David J. Johnson
Director
Service Engineering Operations
Ford Customer Service Division

July 26, 2022

SUBJECT: **NEW VEHICLE DEMONSTRATION / DELIVERY HOLD**
Safety Recall 21S53 - Supplement #1
Certain 2018 Model Year F-150 built at Dearborn Assembly
Tailgate Latch Replacement

FIGURE 1

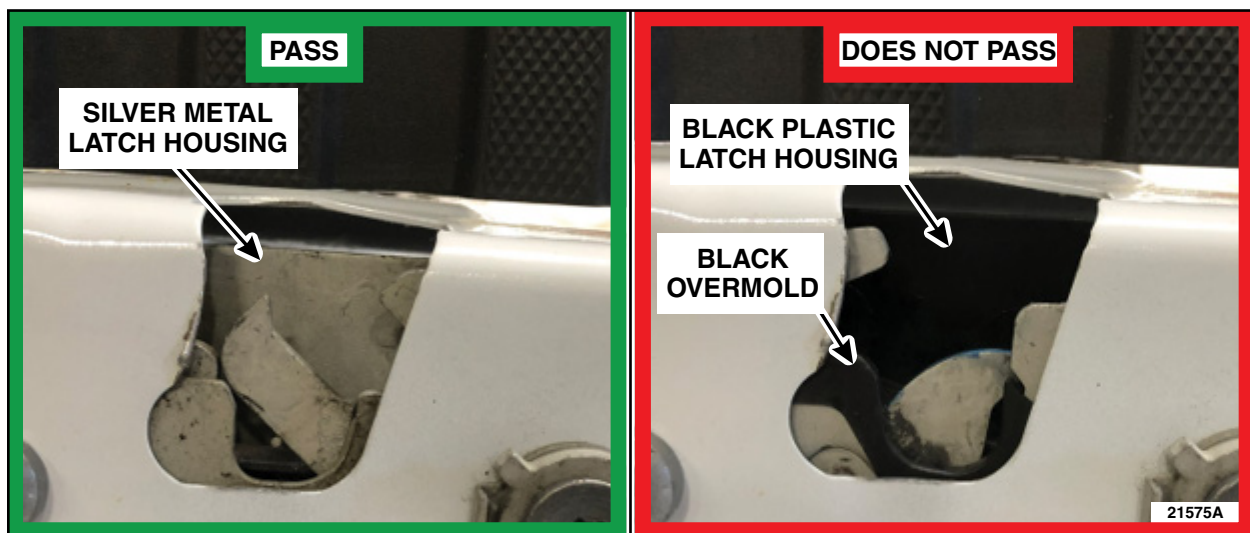
1. Lower the tailgate and inspect both latches for either a black plastic latch housing or a silver metal latch housing. See Figure 1. The black plastic housing is not to be confused with any bed liner over spray. See Figure 2.

PASS - Both latches have a silver metal housing and does not require replacement. This completes the recall.

DOES NOT PASS - Either latch has a black plastic housing and requires replacement. Replace the affected latch(es) by following the Workshop Manual (WSM) procedures in Section 501-14.
